# REGIONAL REVIEW FINDING

ARC REVIEW CODE: R1410071

**Name of Proposal:** Atlanta Media Center  
**Submitting Local Government:** Gwinnett County  
**Review Type:** Development of Regional Impact  
**Date Opened:** October 7, 2014  
**Date Closed:** October 22 2014

**SUBJECT:** **Transportation Division Review of DRI # 2443**

DRI SITE PLAN  
DRI #2443

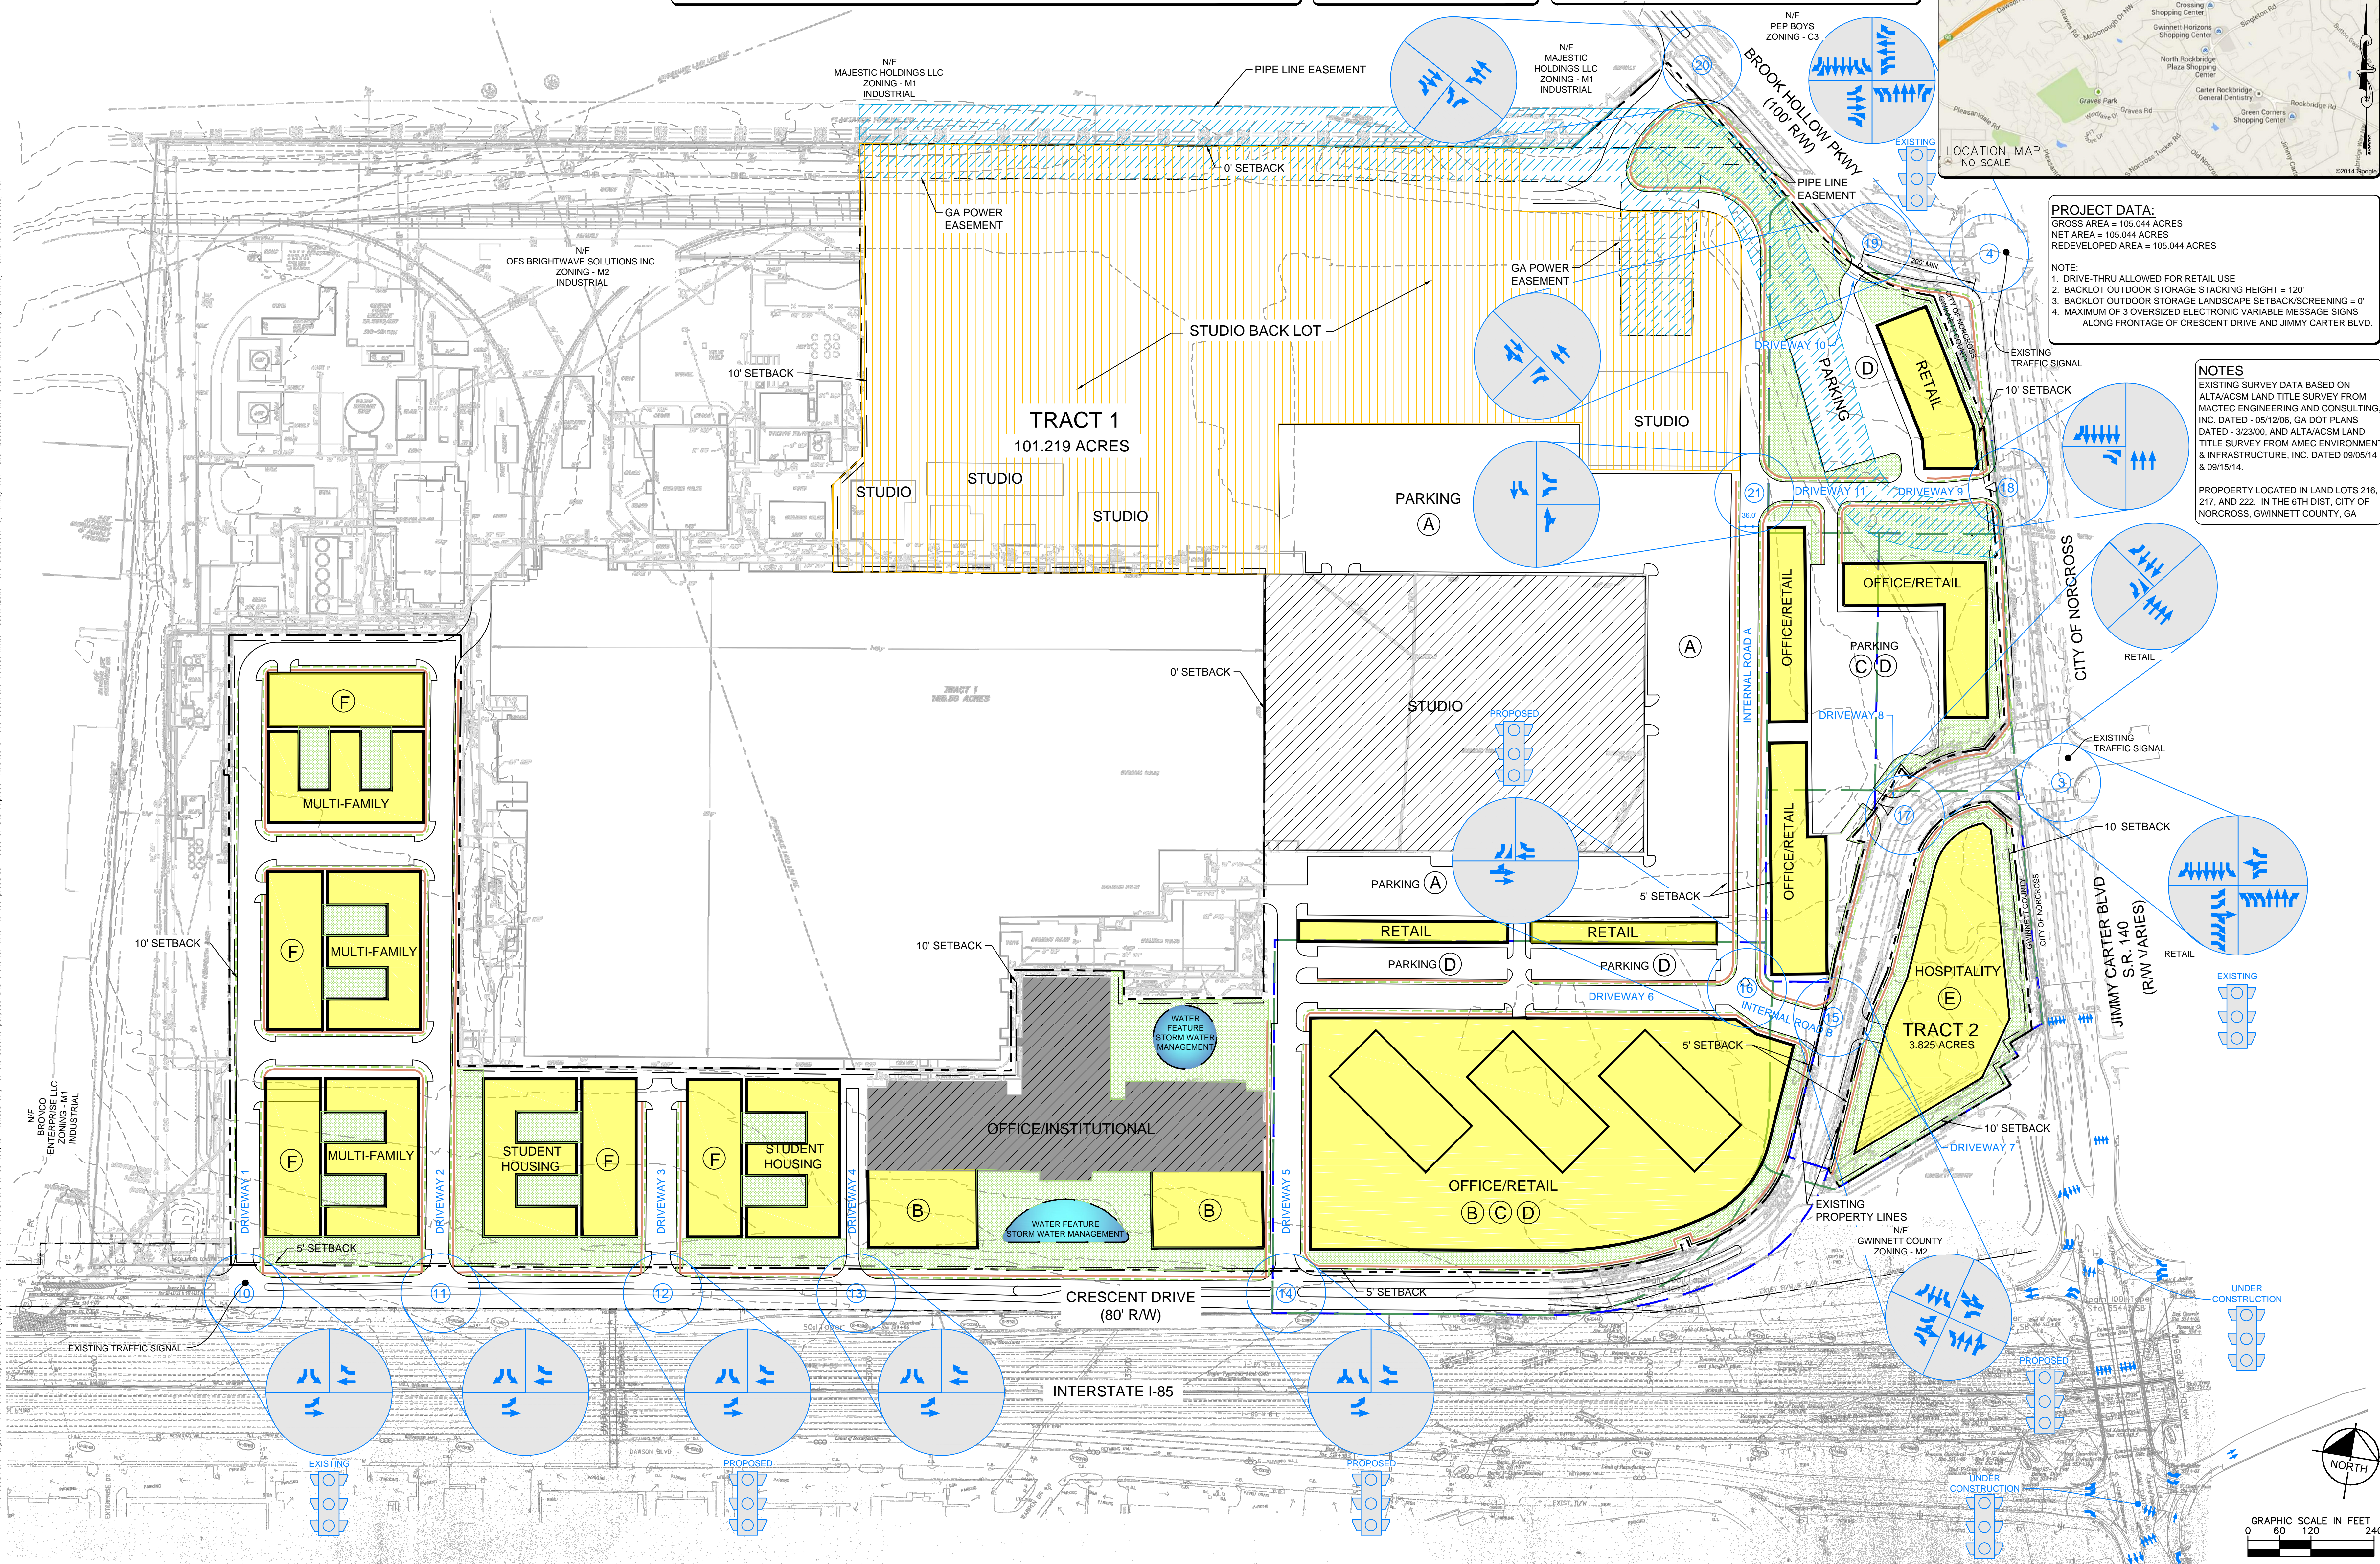
The DRI traffic study assumes an alternative transportation mode reduction of 10.0%. To achieve this level of alternative mode use, adequate bike and pedestrian facilities are needed along adjacent roadways as well as within the site. The DRI site plan identifies locations of sidewalks but does not show bike facilities.

- The site plan should show adequate space for recommended transportation improvements on-site. Construction of structures or other facilities on-site should not create obstacles or otherwise preclude implementation of the recommended transportation improvements.

- The DRI traffic study assumes an alternative transportation mode reduction of 10.0%. To achieve this level of alternative mode use, adequate bike and pedestrian facilities are needed along adjacent roadways as well as within the site. The DRI site plan identifies locations of sidewalks but does not show bike facilities. The site plan should identify the locations of bike

facilities, and the applicant should work with Gwinnett County to determine the preferred facility type(s).

- The applicant should review the *I-85 Corridor Light Rail Transit Feasibility Study, September, 2008*, to ensure the proposed site plan does not create obstacles or otherwise preclude construction of rail transit at the project site.
